OAKLAND ELEVATORS LTD - SAFETY GEAR ROPE SNAGGING

Safety Gear Rope Snagging

TI no: 001

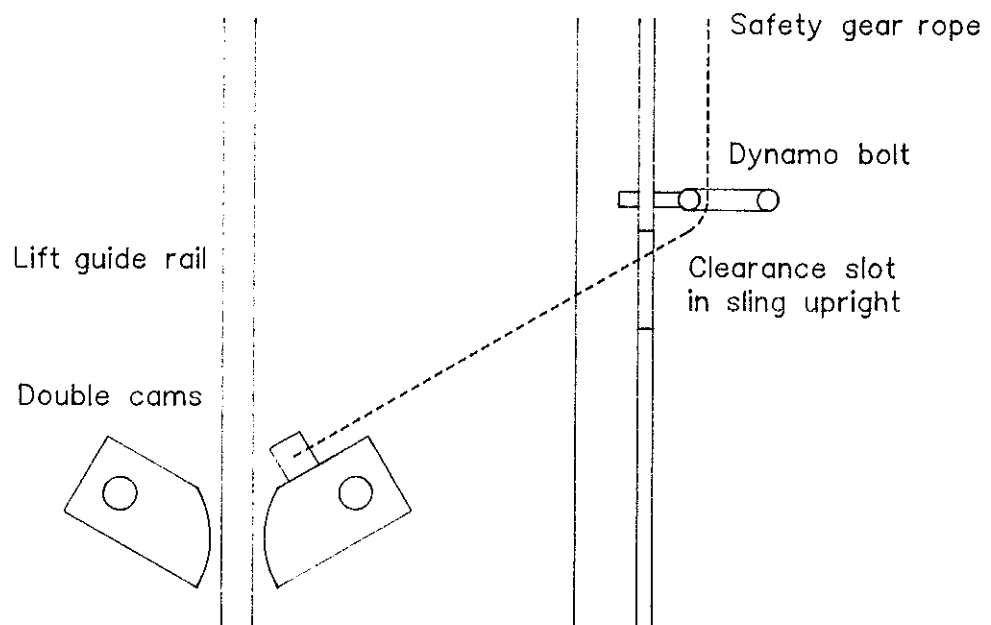
The problem relates to a safety gear rope which upon close inspection was found to pass through potential snagging points for the installation in question. Upon testing the safety gear has always been found to operate satisfactorily. However, work has now been carried out to remove the possibility of the rope snagging.

The normal arrangement (see sketch below) at the time, was to fit a dynamo bolt to 'guide' the rope through a clearance slot in the sling upright.

Please closely examine all Oakland electric traction lifts installed prior to 1982 end, which are fitted with instantaneous double cam safety gear.

If any 'potential' snagging points are found, it is suggested that rectification work is undertaken.
